401 Summit Court
Russell Bate
Tentative Map

M-79-18
9/12/79

REPORT TO: The Planning Commission
FROM: Lee E. Bowman, Planning Director
SUBJECT: Subdivision Application M-79-18
3-lot subdivision
APPLICANT: Russell Bate
LOCATION: Surmont Court
EXHIBITS: A. Tentative map, received December 7, 1979 (previously distributed).
B. Staff report, dated January 4, 1980 (previously distributed).

REPORT TO: The Planning Commission
FROM: The Development Review Committee
SUBJECT: Subdivision Application M-79-18
APPLICANT: Russell Rite
LOCATION: 401 Summit Court
ZONE: HR-2½ (Hillside Residential - 2½-10 acres per dwelling unit)
FINDINGS: As required by the Map Act
ACTION: The decision of the Planning Commission is final unless
appealed within 15 days.

PRELIMINARY MAP
 for RUSSELL BATE

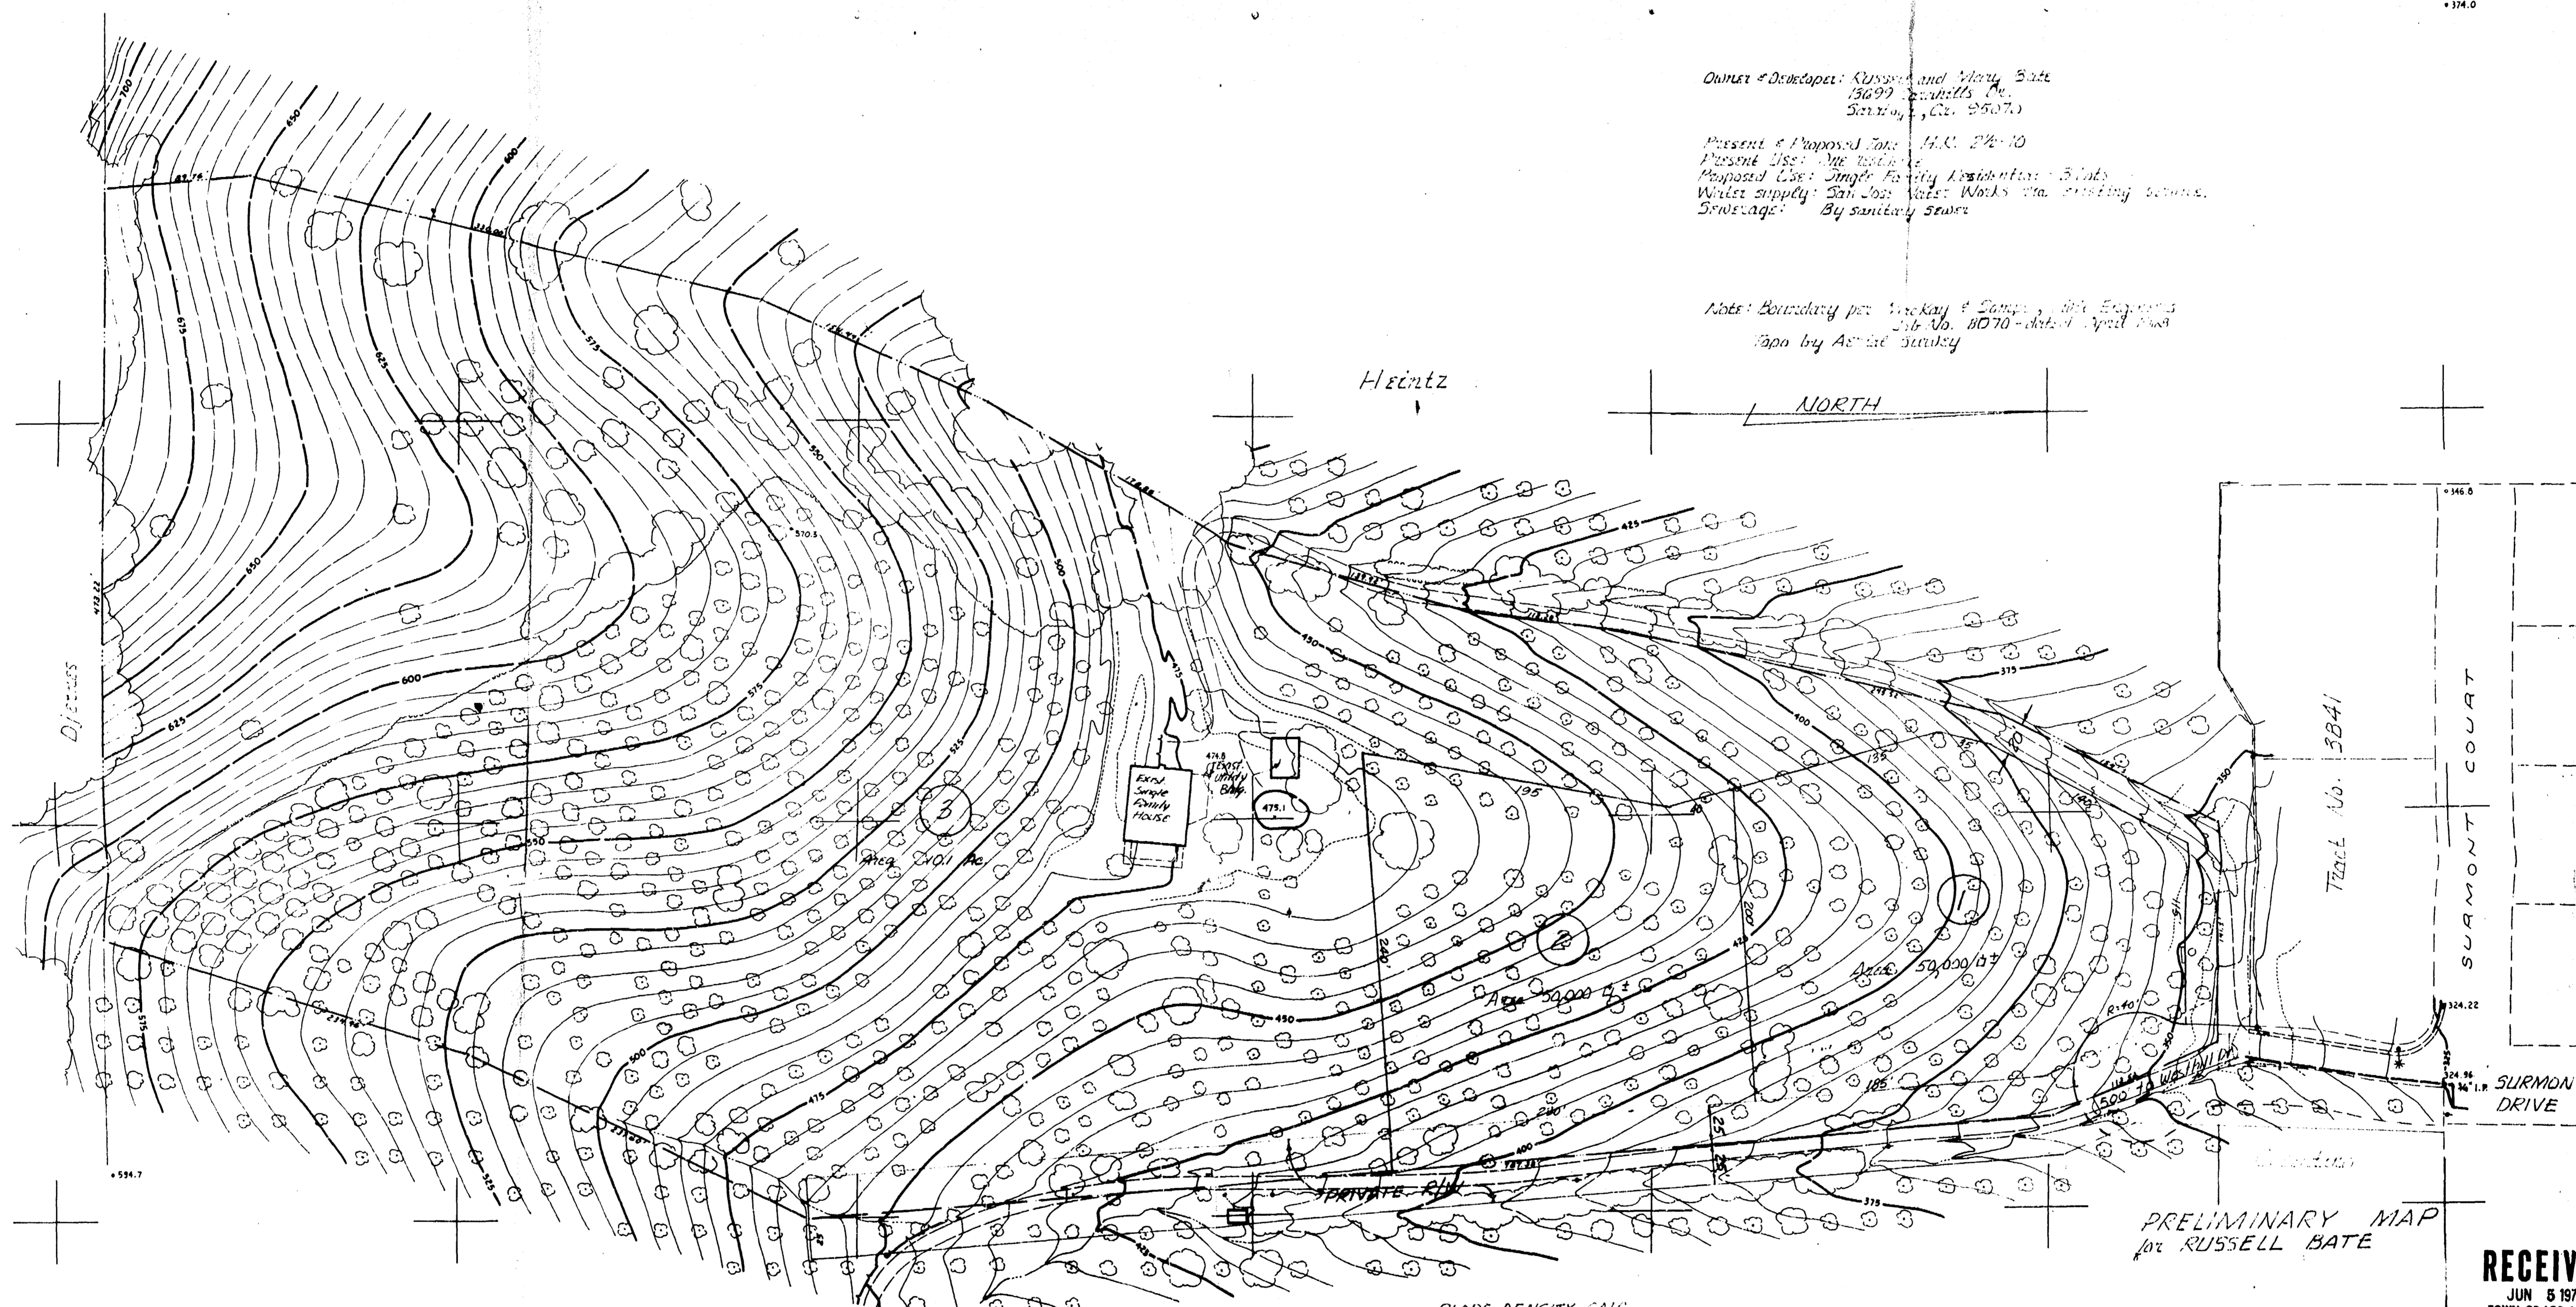
1. Our main concern with the proposal is the access for this property and adjacent properties. The existing driveway along the east property line is in the same location as a connector road between Summit Drive and Belgato^s, shown on the General Plan. A recent Tentative Map approval on the Das property, adjacent to Belgatos Road, required construction of a part of the eastern portion of this connector road. It will function temporarily as a driveway. It is our opinion that this application should be conditioned with improving a portion of this connector road from Furmont Drive to a point approximately 250 feet south of the southeast corner of the proposed Lot #2. The roadway should be improved to at least an 18-foot width (as required for a multiple use driveway) with curb and gutter on one side. This roadway should be designed to become a part of the ultimate roadway. The right-of-way should be dedicated, and rejected initially, with the option of future acceptance if needed for public use. A typical section should be shown on the Tentative Map.

2. The Tentative Map should include a concept plan for storm and sanitary sewer and show how the two new parcels could be developed.
3. We recommend that development not be allowed with the private water system proposed. The upper portion of the Das property,

the adjacent Anderson property and this parcel are served, or proposed to be served, with individual pump systems. If this parcel is allowed to develop to its ultimate density without public water, there will be fewer participants and lesser possibility of a joint project to bring in public utility water for this area.

4. The grading impact for any roadway construction, including removal of any trees, shall be shown on the Tentative Map.

1. The water is proposed to be supplied by San Jose Water Company via an existing service line. The water would then be pumped to a reservoir above the highest dwelling and then a gravity system back to the proposed new lots for service and fire flow.
2. Construct a turn around now at a location 500 feet from Westhill Drive and serve lot 2 via a 25 foot corridor which in the future would be part of a public street.
3. Let the existing driveway to lot three (3) remain as is in width and improvement since the new parcels would have access from either the cul de sac or a new driveway.

M-79-18

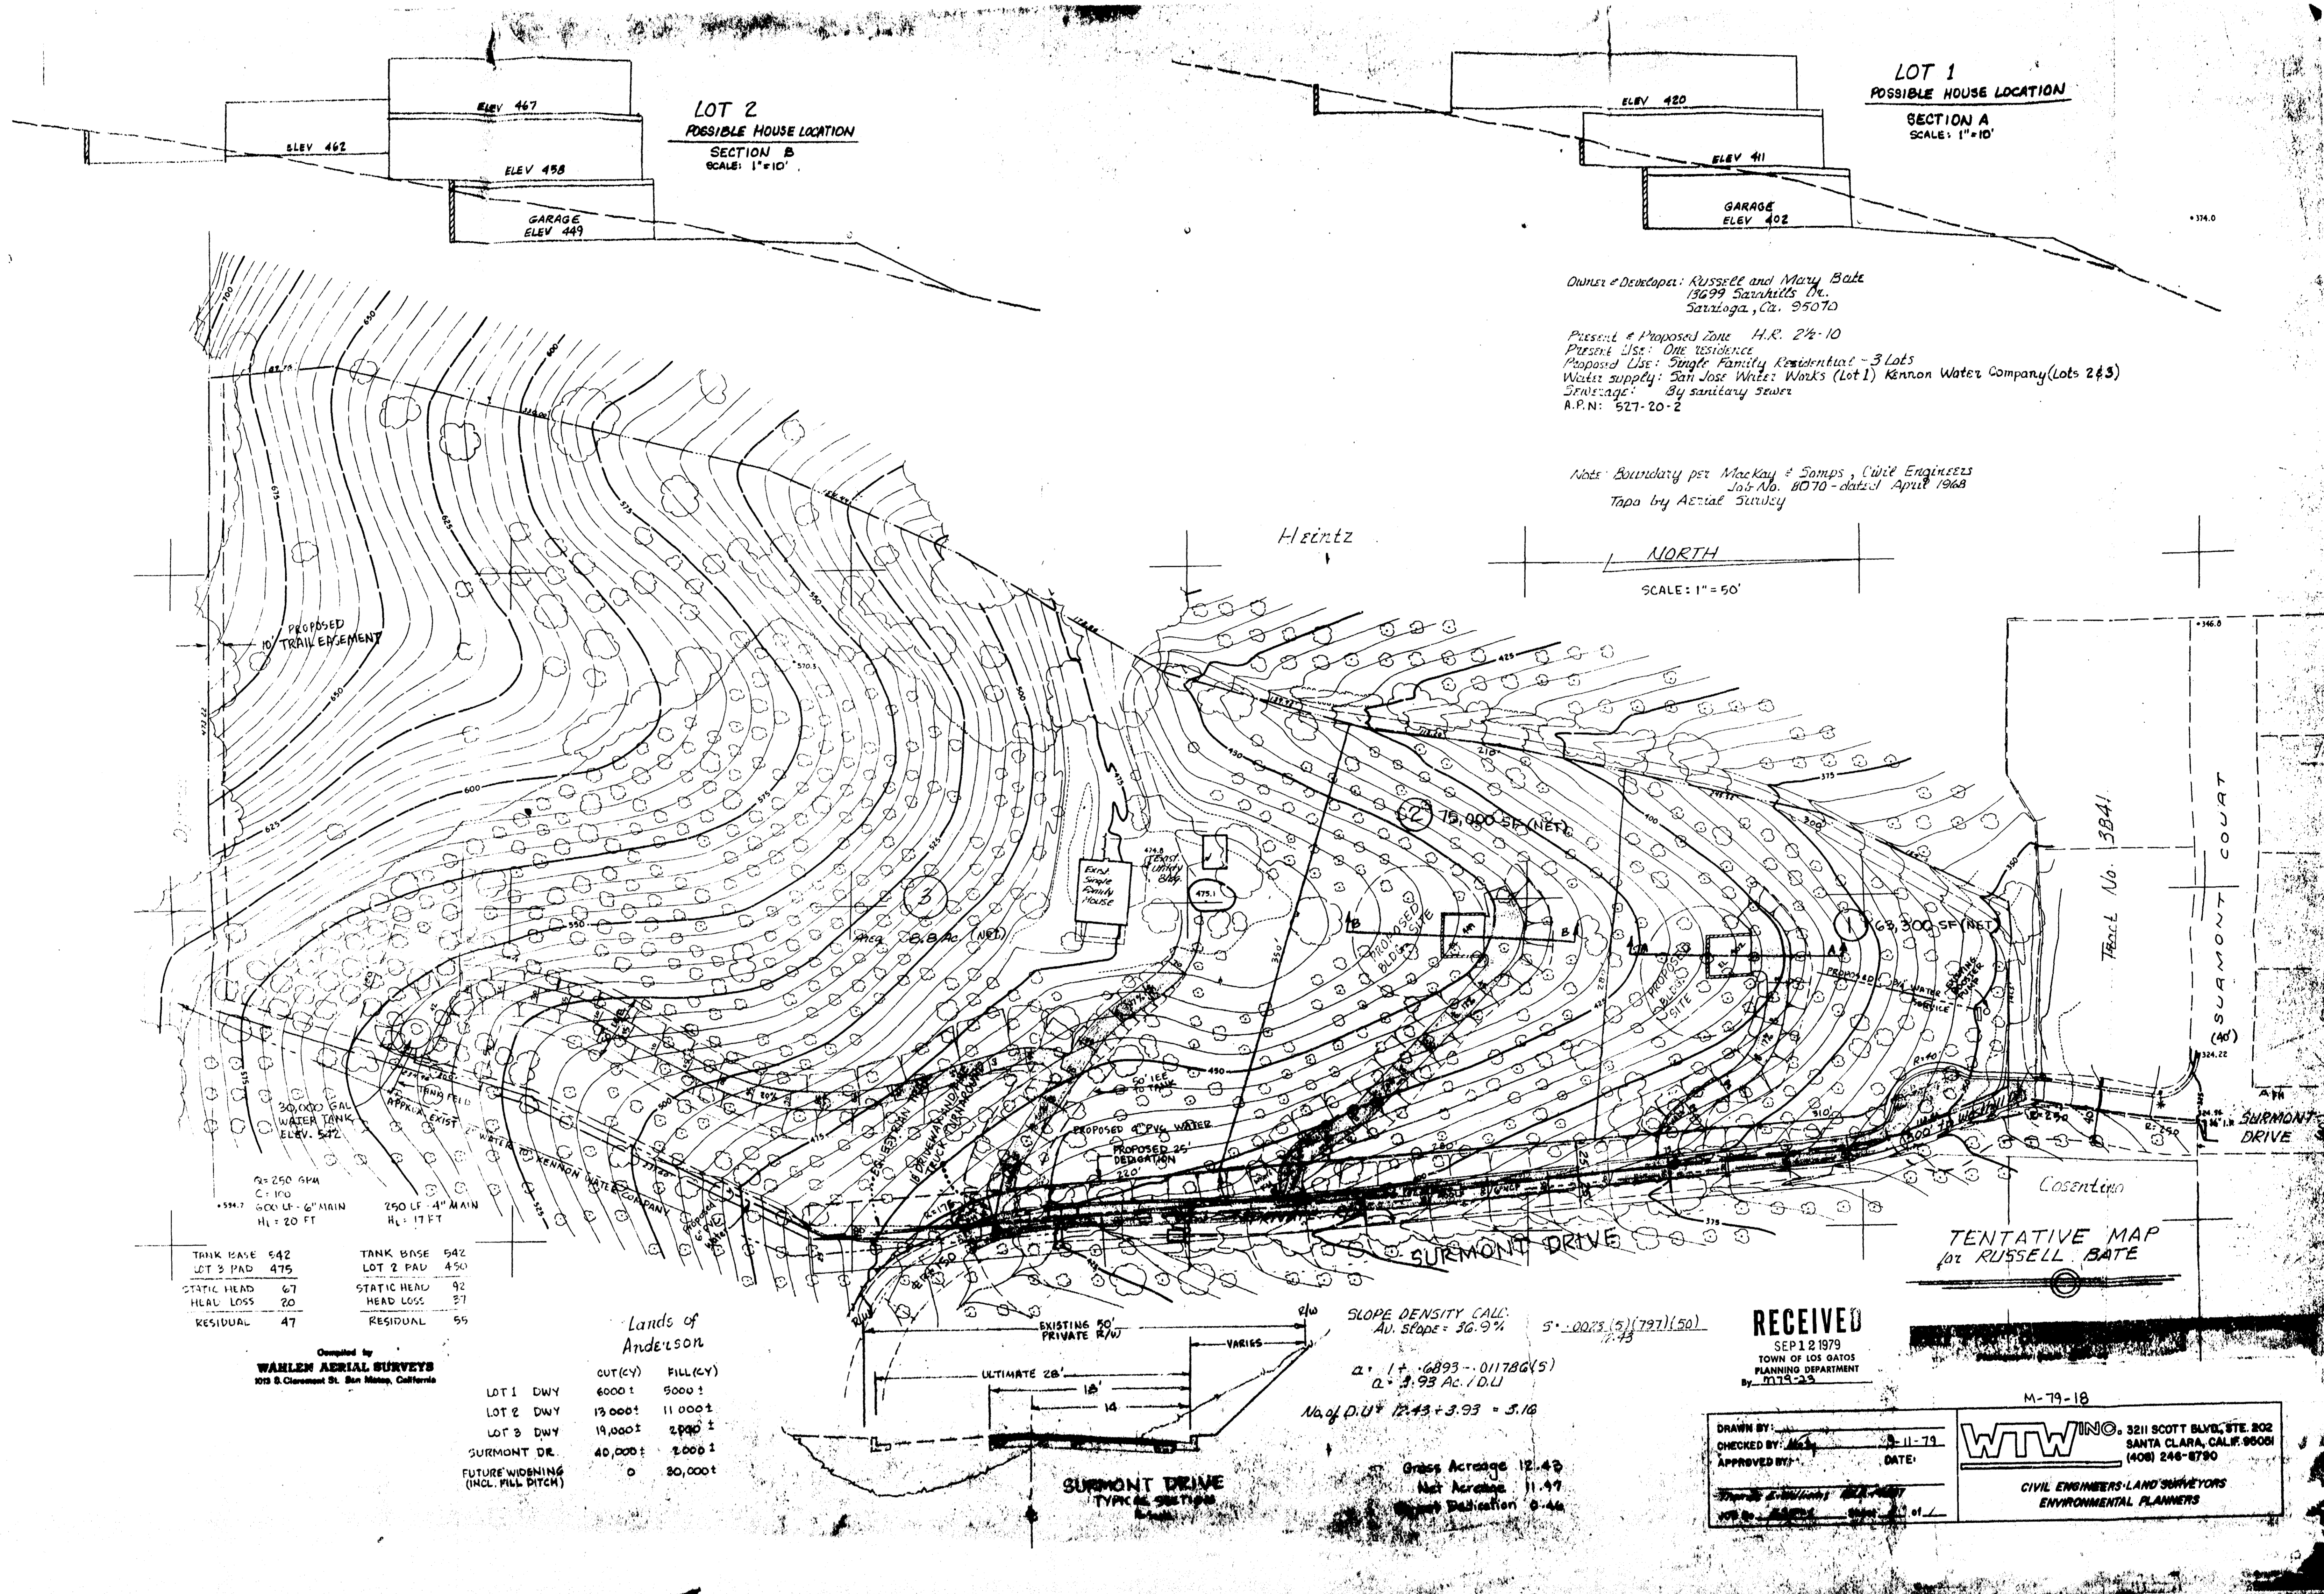
1. The preliminary map for this subdivision was reviewed by the DRC in June, 1979. A Tentative Map is now submitted for review. Our main concerns with the proposal are water supply and the access for this property and adjacent properties. The existing driveway along the east property line is in the same location as a connector road between Surmont Drive and Belgatos, shown on the General Plan. A recent Tentative Map approval on the Das property, adjacent to Belgatos Road, required construction of a part of the eastern portion of this connector road. It will function temporarily as a driveway. It is our opinion that the conditions of approval of this application include improvement of a portion of this connector road from Surmont Drive to a point approximately 250 feet south of the southeast corner of the proposed Lot #2. The roadway is shown to be improved to an 18-foot width (as required for a multiple use driveway) with curb and gutter on the west side. The plan shows the roadway along the alignment of the existing roadbed with a 10-foot-high cut bank on the west side and approximately 2 feet of fill along the east side. Erosion control measures should be shown for the cut and fill slopes. The right-of-way should be dedicated, and rejected initially, with the option of future acceptance if needed for public use. A typical section is shown on the Tentative Map properly indicating an

ultimate 28-foot-wide roadway. A sidewalk is not included with the proposed improvements but can be provided on the east side of the roadway when that property develops.

2. The Tentative Map shows a concept plan for sanitary sewer with a 6-inch main proposed to be installed for the full length of the roadway. The connection to the existing sanitary system and laterals serving the 3 lots should be shown.

3. The Tentative Map does not show a concept plan for storm sewer installation or how the runoff from the lots and roadway is to be handled.
4. The upper portion of the Das property, the adjacent Anderson property and this parcel are served, or proposed to be served, with individual pump systems. The proposed water system consists of the installation of a 30,000 gallon storage tank located in the southeast corner of Lot #3 to be fed by a private 2-inch water line (owned by the Kennon Water Company). It apparently runs between Blossom Hill Road and Shannon Road. Lots #2 and #3 are proposed to be gravity fed by new 6-inch and 4-inch water mains from the storage tank. Lot #1 is proposed to be served from an existing booster pump located at the northerly side of the lot. We think this pump now serves the existing house on Lot #3. Three-quarter inch water services are proposed for each of the 3 lots. We feel these should be increased to at least 1-inch services. We recommend that development not be allowed to use the private water system proposed. We are opposed to the proliferation of small private systems. The Town's policy is for all new development

to be served by a public water system. If this parcel is allowed to develop to its ultimate density without public water, there will be fewer participants and lesser possibility of a joint project to bring in public utility water for this area. We suggest that the applicant contact San Jose Water Works and the adjacent property owners to assist the applicant in developing a publicly maintained water system for this project as well as for the adjacent properties (Das, Anderson, etc.).

5. The lot configuration shown on the Tentative Map is much more desirable, from an access point of view than what was originally shown on the Preliminary Map. The Preliminary Map showed all access directly off a cul-de-sac at Summit Drive. The grade of the driveways to the three lots shown on the Tentative Map range from 17 to 20%. They will require extensive grading with up to 8-foot cuts and retaining walls indicated. The driveways will be a minimum of 12 feet wide plus 3-foot shoulder. They are over 150 feet long so they will require one turnout per driveway. Building site grading indicates tri-level homes proposed for Lots #1 and #2. Grading for garage pads will require a cut of 11 feet for Lot #1 and a cut of 8 feet for Lot #2. Cuts are to be retained with foundation walls. Existing trees are shown on the Tentative Map but it is not indicated how many trees will be required to be removed or what specie the trees are.
